ABBREVIATED PLAT AGENDA

**STAFF REVIEW AND RECOMMENDATIONS
PUBLIC HEARING
MARCH 15, 2023**

PRELIMINARY PLAT: RIVERDELL ESTATES RSB BLOCK 5 LOT 9A
LEGAL DESCRIPTION: SEC 30, T17N, R01W, SEWARD MERIDIAN AK
PETITIONER: ZERIAH LLC
SURVEYOR/ENGINEER: DENALI NORTH
ACRES: 7.11 ± PARCELS: 3
REVIEWED BY: AMY OTTO-BUCHANAN CASE #: 2023-013

REQUEST: The request is to create three lots from Lot 9A, Block 5, Riverdell Estates, Plat No. 78-166, to be known as **LOT 9B, LOT 11A and LOT 13A**, containing 7.11 acres +/- . The parcel is located south of W. Marble Way and directly east of S. Loussac Lane; within Section 30, Township 17 North, Range 01 West, Seward Meridian, Alaska.

TEST HOLE No. 4

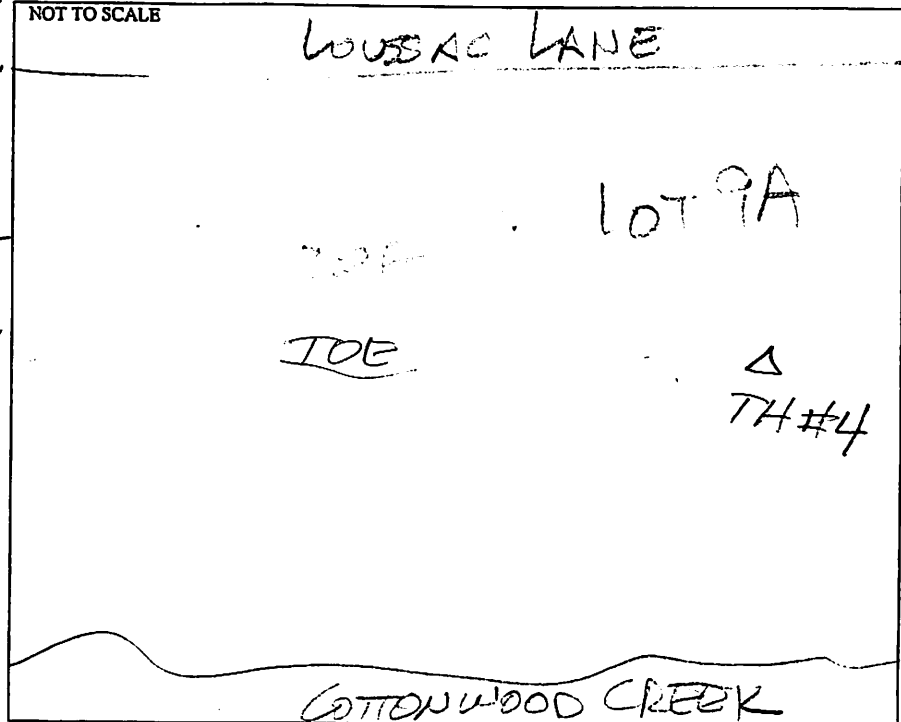
Comments: Department of Public Works (**Exhibit D**) notes testhole #4 shows water level encountered during drilling at approximately 7' below ground surface. MSB 43.20.281(A)(1)(a) states that seasonal

high water table must be a minimum of 8' below ground surface. Given this, the line delineating useable septic area should not include testhole #4 (see **Recommendation #5**). Department of Emergency Services (**Exhibit E**) has no issues. Development Services (**Exhibit F**) has no comments.

TH-4 shows water level encountered during drilling at approximately 7' below ground surface. MSB Code 43.20.218 (1)(A) states that the seasonal high water table must be a minimum 8 feet below ground surface. Given this, the line delineating usable septic area should not include TH-4.

TOPO/DRAINAGE MAP

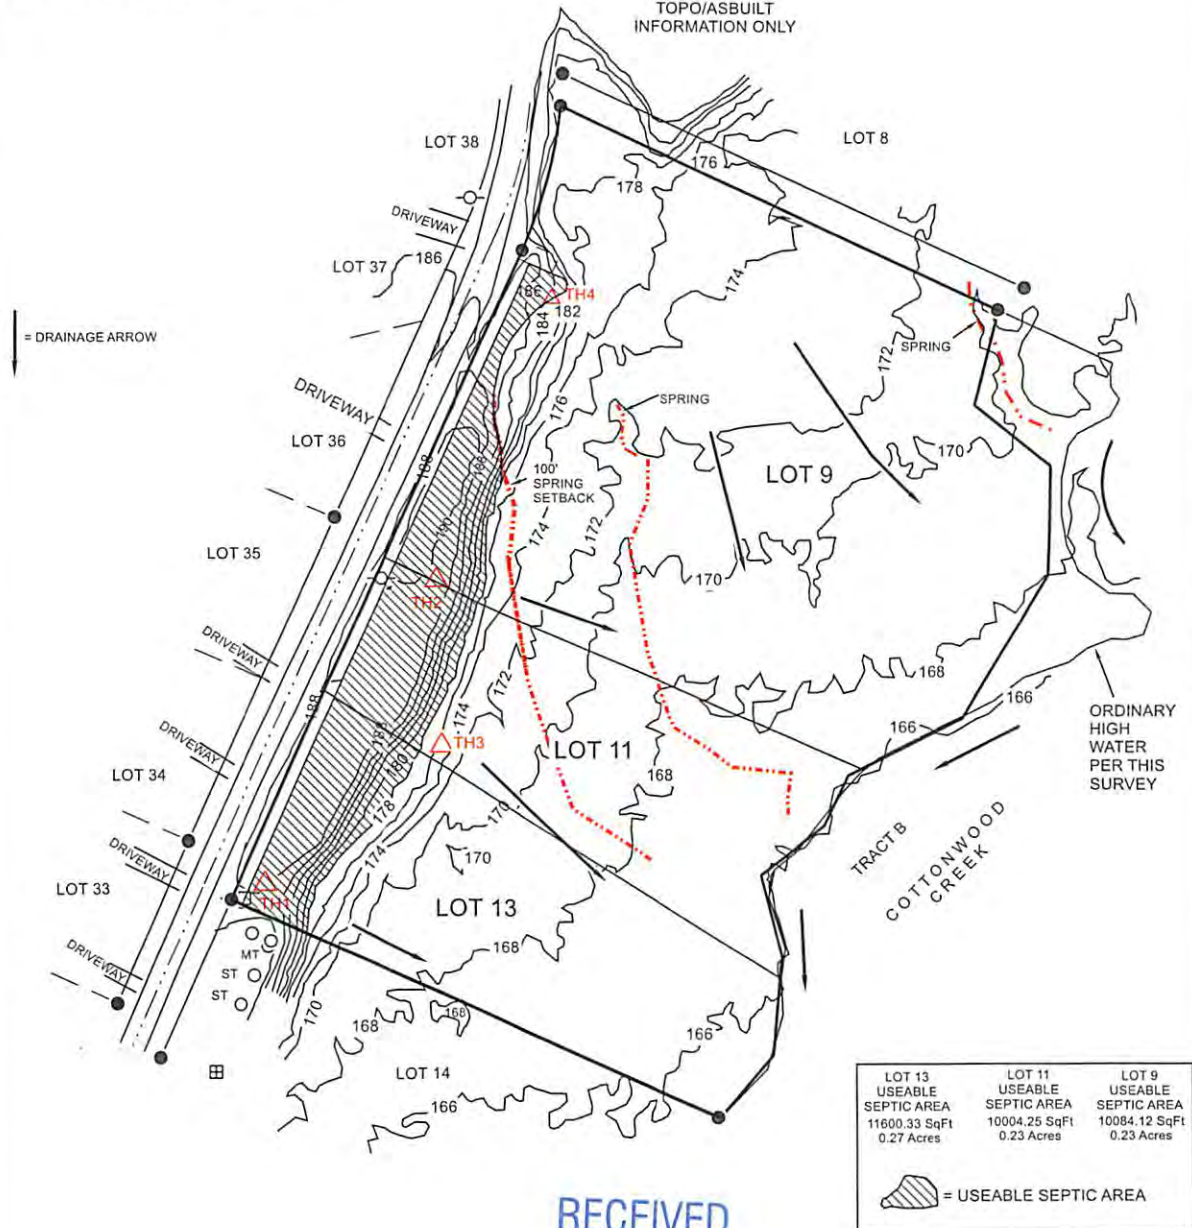
Soils Report: (**Exhibit B**) A soils report was submitted pursuant to MSB 43.20.281(A). James Rowland, PE, notes testhole logs from August 21, 2021 are attached and location of testholes are shown on the topographic map. Soils conditions are suitable for conventional on-site wastewater disposal systems. There is a minimum of 10,000 sf of useable building area and 10,000 sf of contiguous useable septic area within each of the proposed lots. Drainage patterns will not be altered as a result of this subdivision. Topographic mapping and As-Built is at **Exhibit C**.

PRELIMINARY PLAT

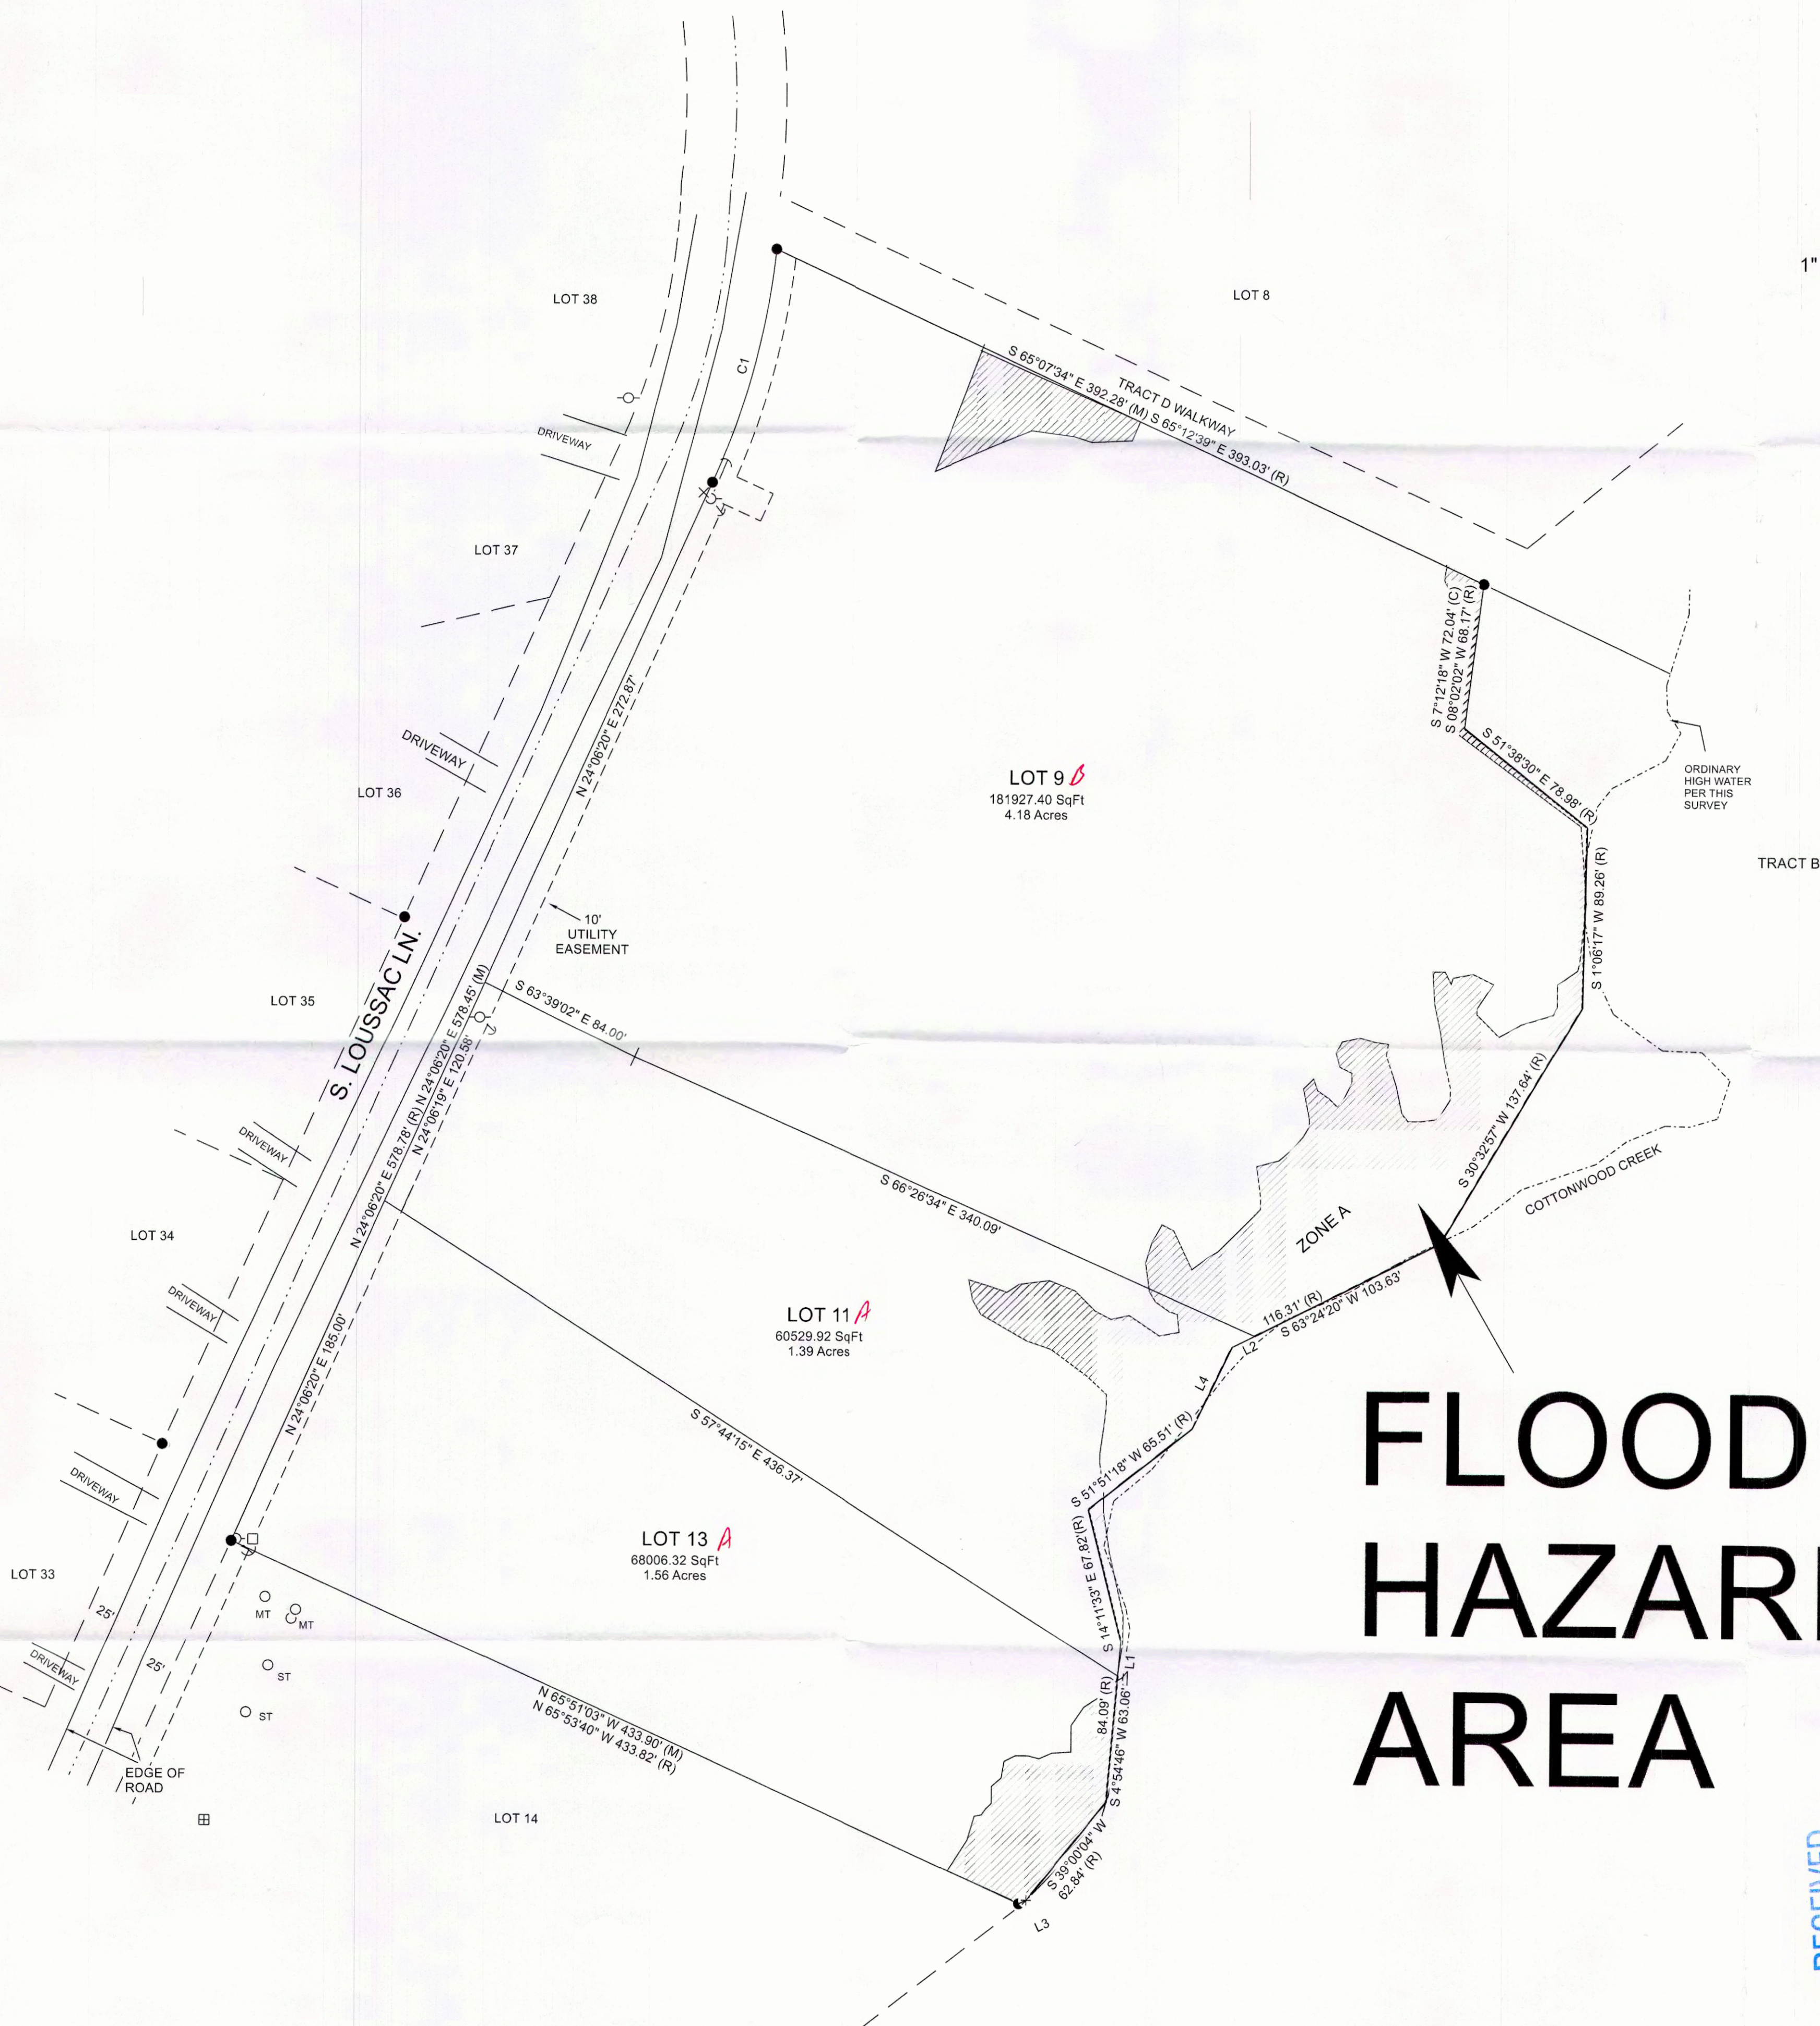
1. Lot 9A has several small tributaries of Cottonwood Creek running throughout it. Some of which run right up to the only possible building spaces on the property. Coho Salmon use these tributaries for spawning, far away from the main body of Cottonwood Creek. Every once in a while, Chinook Salmon also will spawn in these tributaries. Sockeye Salmon use these as well, but don't spawn in them.

2. Inevitably, over development of this property will diminish these waterways used by the Salmon and their Frye every year.
3. Every Spring Mallard Ducks and other waterfowl species use these tributaries for cover from Eagles and other predators during nesting.

4. This section of the creek is already prone to flooding and has flooded in recent years, including this Winter. Development of this property can only make the surrounding properties and homes more susceptible to flooding. There has already been a large trench dug by the landowner to divert water away from these tributaries.

My feeling is these low wetlands areas should remain as they are, wetlands. Realistically there is not enough useable land above the low-lying areas to support three households and yards. Not without bringing in even more fill. Which will affect the flooding characteristics, and the wildlife habitat.
